TERMINAL 3 WEST
MODERNIZATION

PACKAGE 6 - VOL 1

CONTRACT NO.	10071.76_400
PROJECT TITLE	TERMINAL 3 WEST MODERNIZATION
SHEET TITLE	PACKAGE 6 - VOL 3
	INT ELEV - LEVEL 2 - CENTRAL CIRCULATION

CONTRACT NO.	PROJECT TITLE	SHEET TITLE	
10071.76_400	TERMINAL 3 WEST MODERNIZATION	PACKAGE 6 - VOL 3	ARTS ENRICHMENT DETAILS

02 ELEV - 02 - 10 - WHEELCHAIR STORAGE BENCH

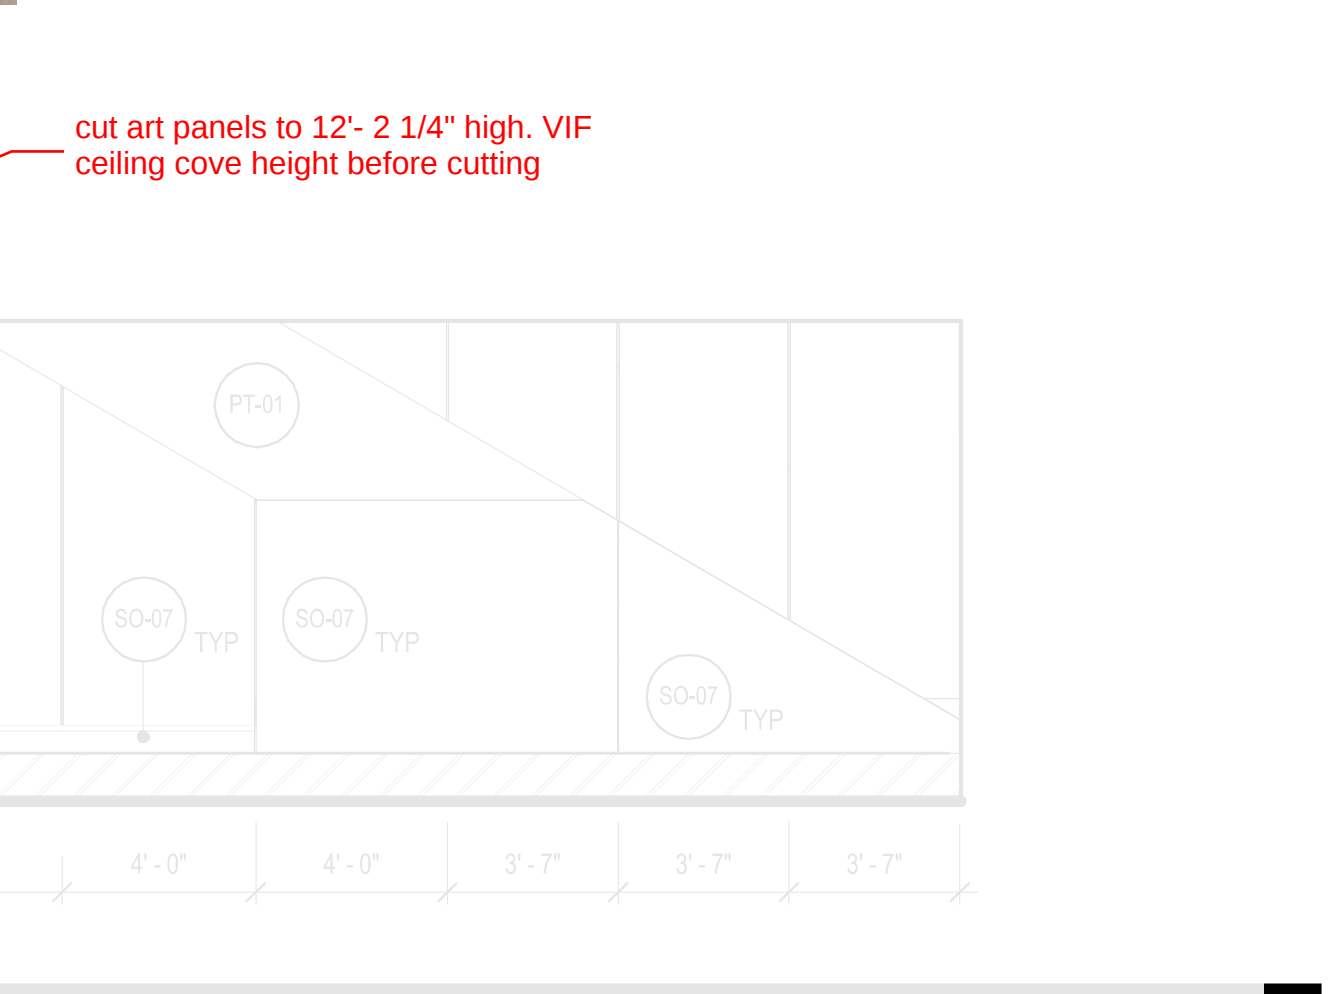
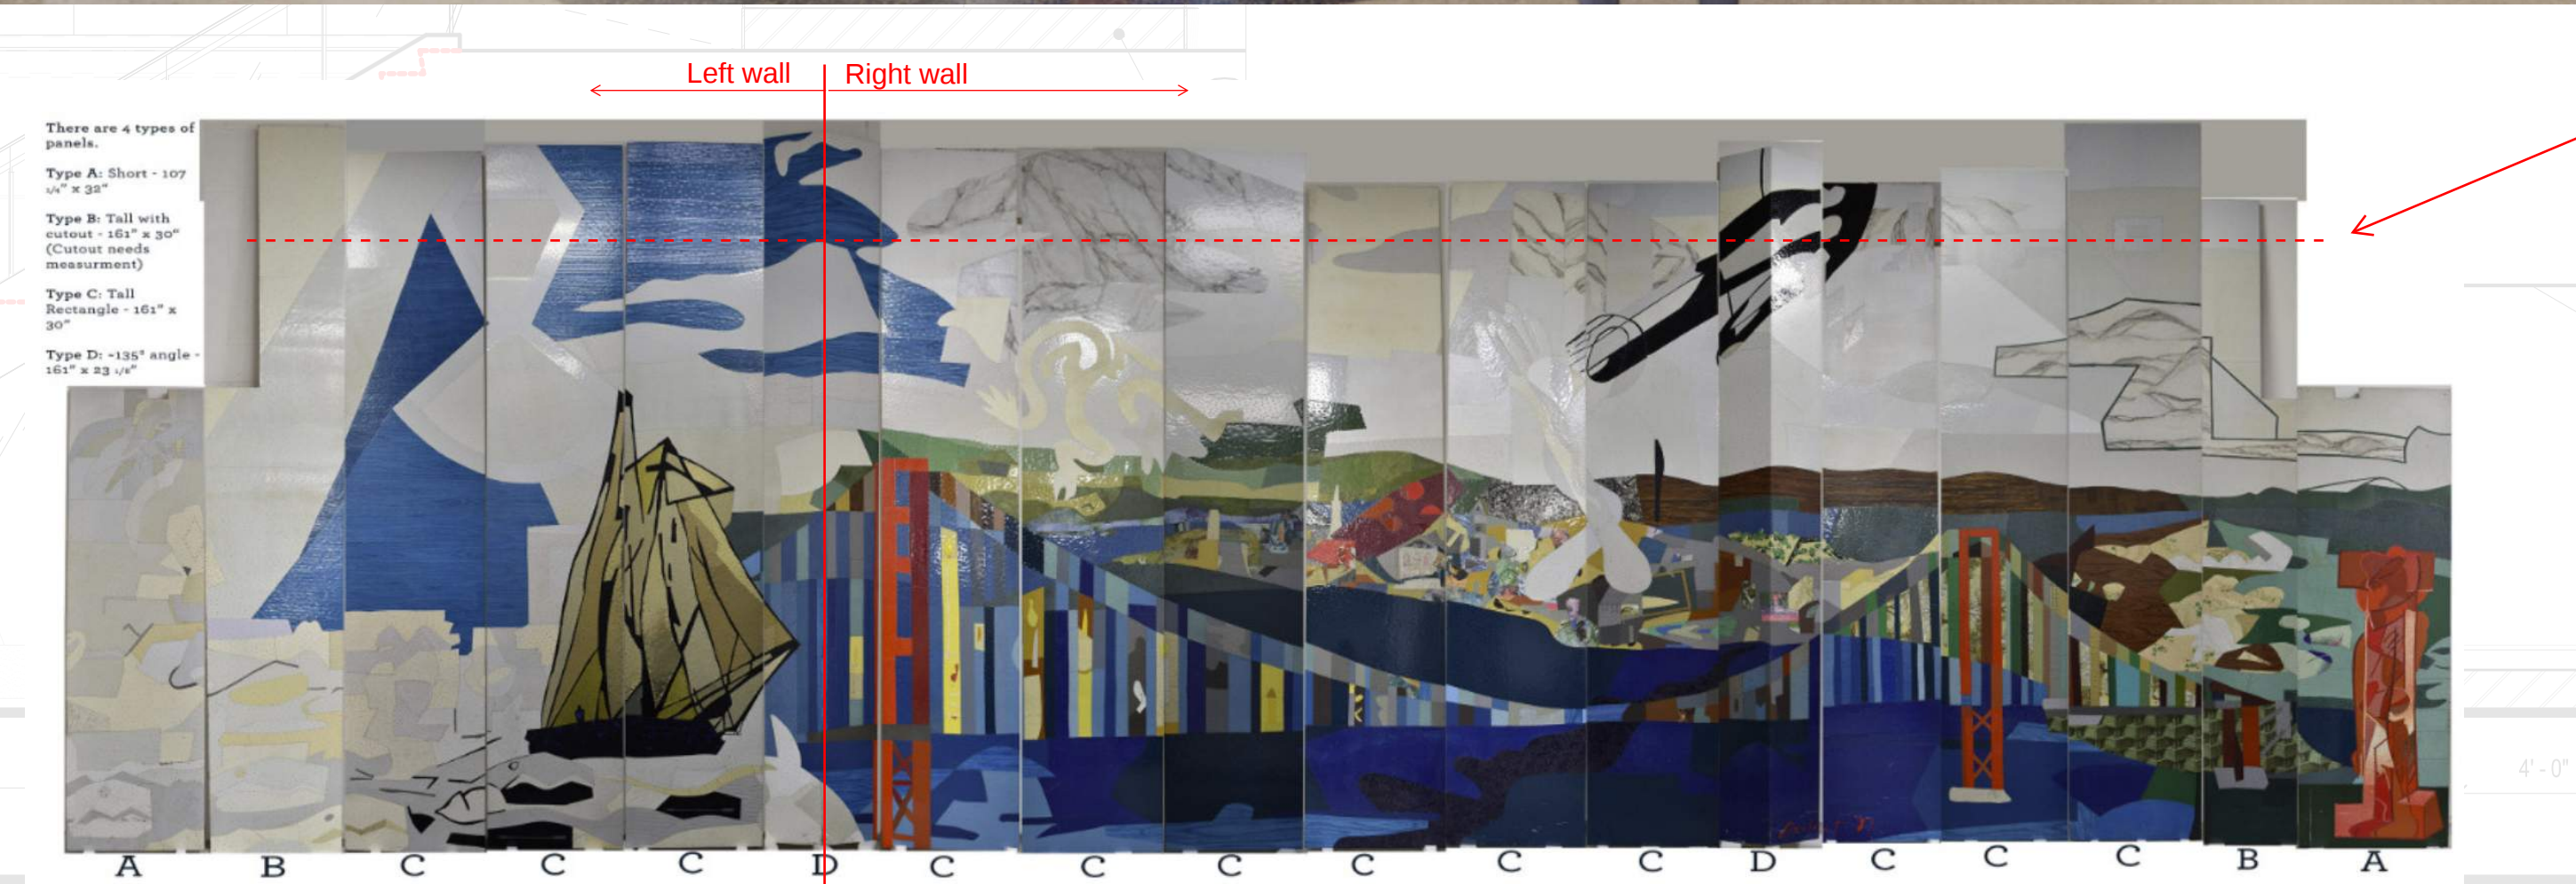
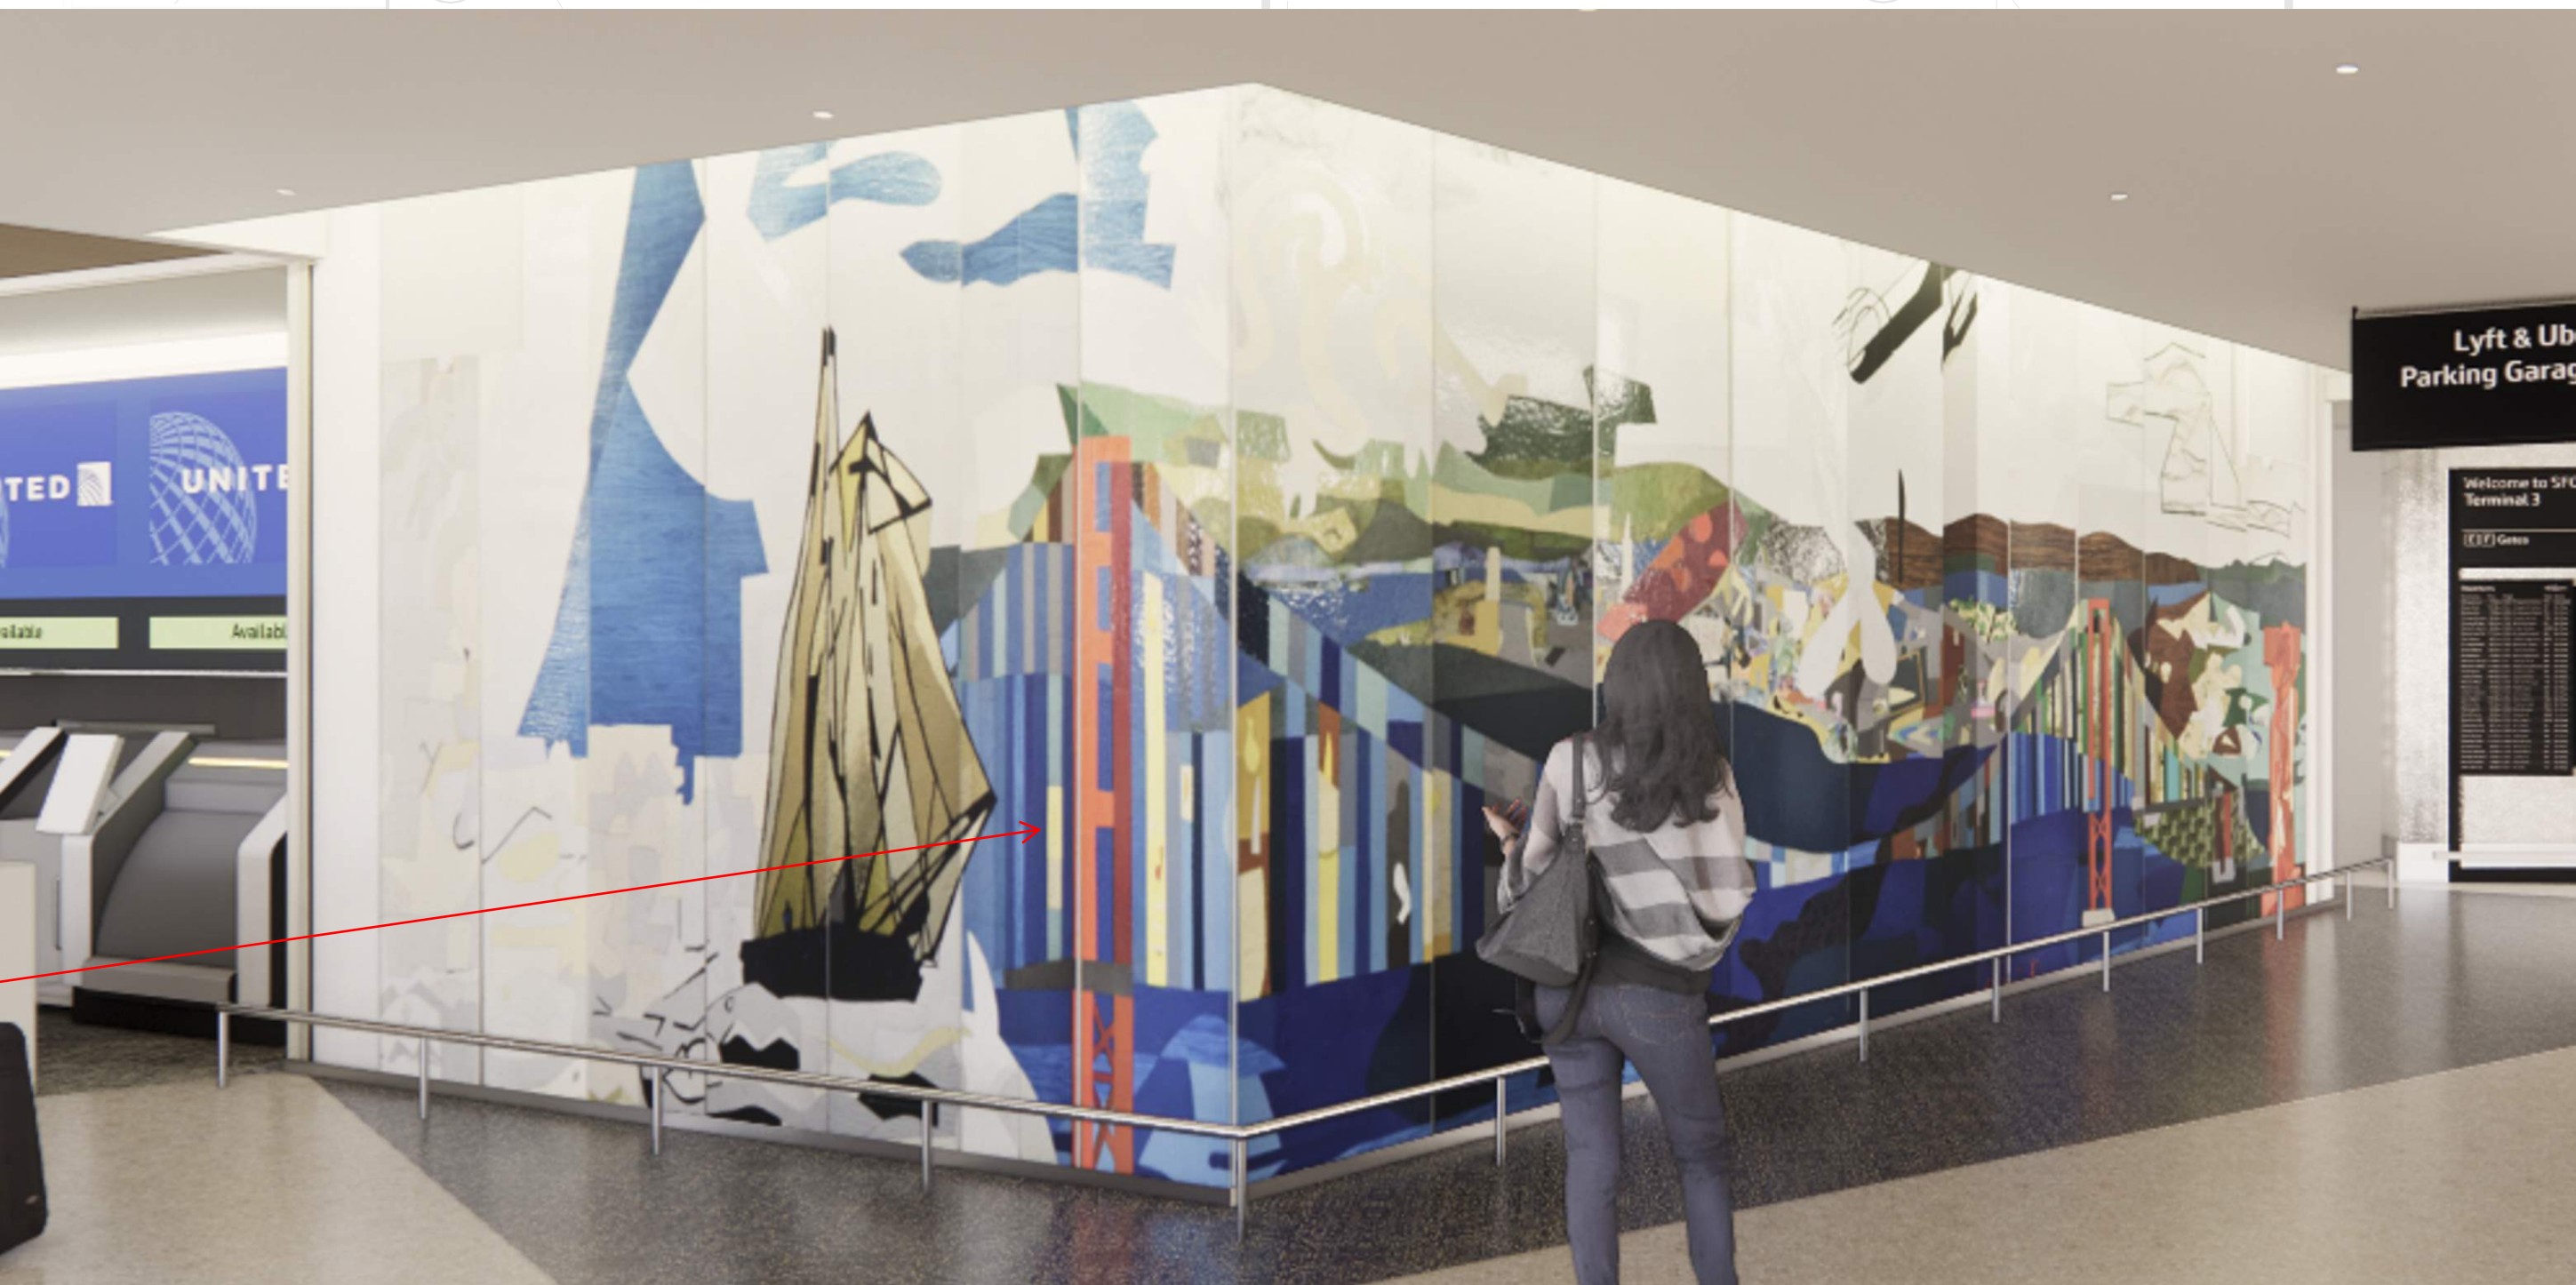
update rendering to show "D" panel at corner
